SDP26-XXXX - SITE DEVELOPMENT PLAN
LOT 4, DAWSON TRAILS FILING NO. 2 AMENDMENT 4

SITE DEVELOPMENT PLAN
LOT 4 DAWSON TRAILS FILING NO. 2 AMENDMENT 4

KEYBANK

SITE PLAN

PLAN VIEW OF THREE-PHASE PAD MOUNTED EQUIPMENT WORKING SPACE AND LANDSCAPING CLEARANCES

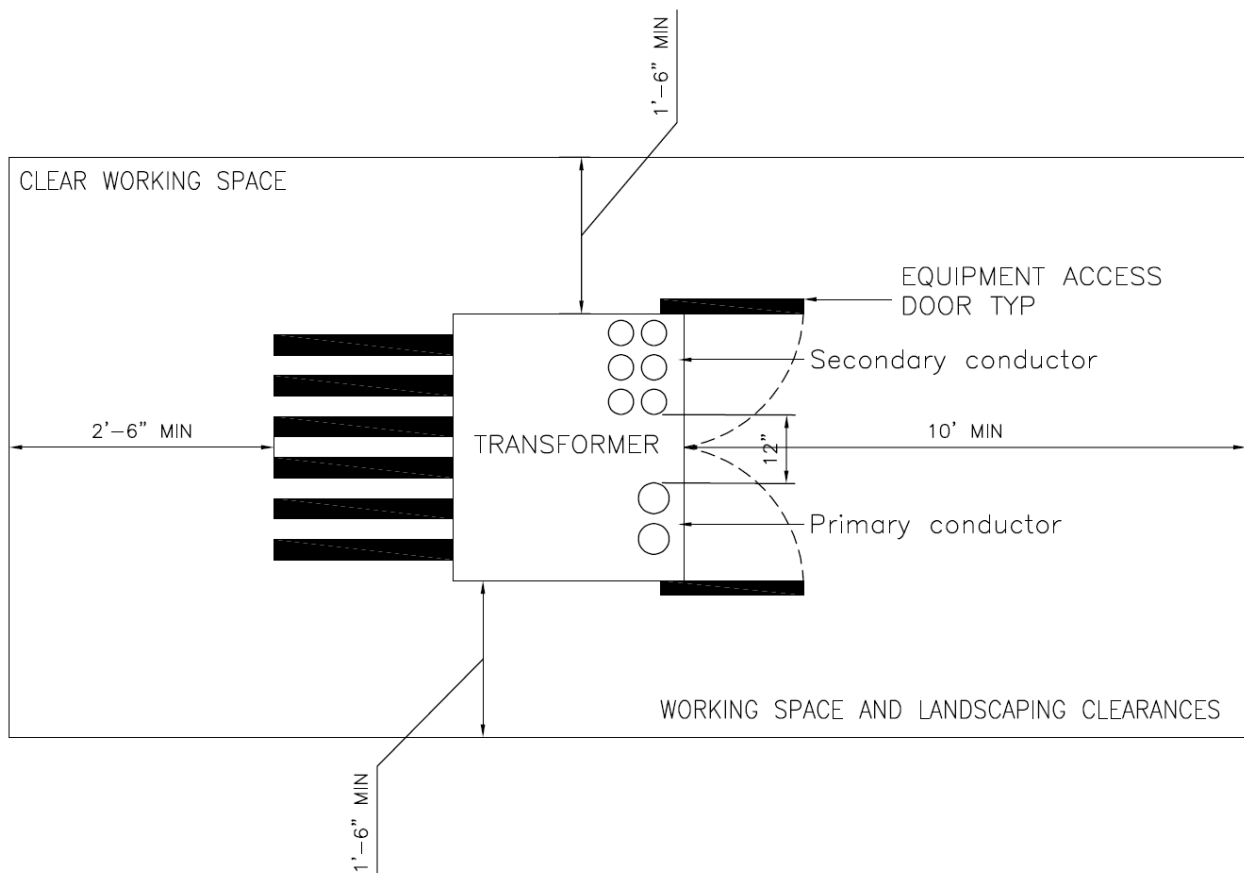
- Three-phase pad mounted equipment with cooling fins shall have a clear working space minimum of 1'-6" on the sides, 2'-6" at the rear of the equipment, and 10' of level ground in front of the equipment. CORE's written approval is required for any variance. Roadways and drive-throughs are not considered working space. Secondary conduits shall be located in the front right quadrant of the transformer and will maintain a minimum separation of 12" between primary and secondary conduits. Secondary cables shall not encroach into the primary side of the transformer.

- CALL OUT EASEMENT WIDTHS BY OTHERS
SHOULD BE DEDICATED VIA PLAT

CORE WILL REQUIRE
A MIN 10' FROM
FRONT OF
TRANSFORMER TO
BACK OF CURB

- Galloway Response:**
Revised indicate
easement widths.

Galloway Response:
Revised to rotate the transformer to provide required clearance.
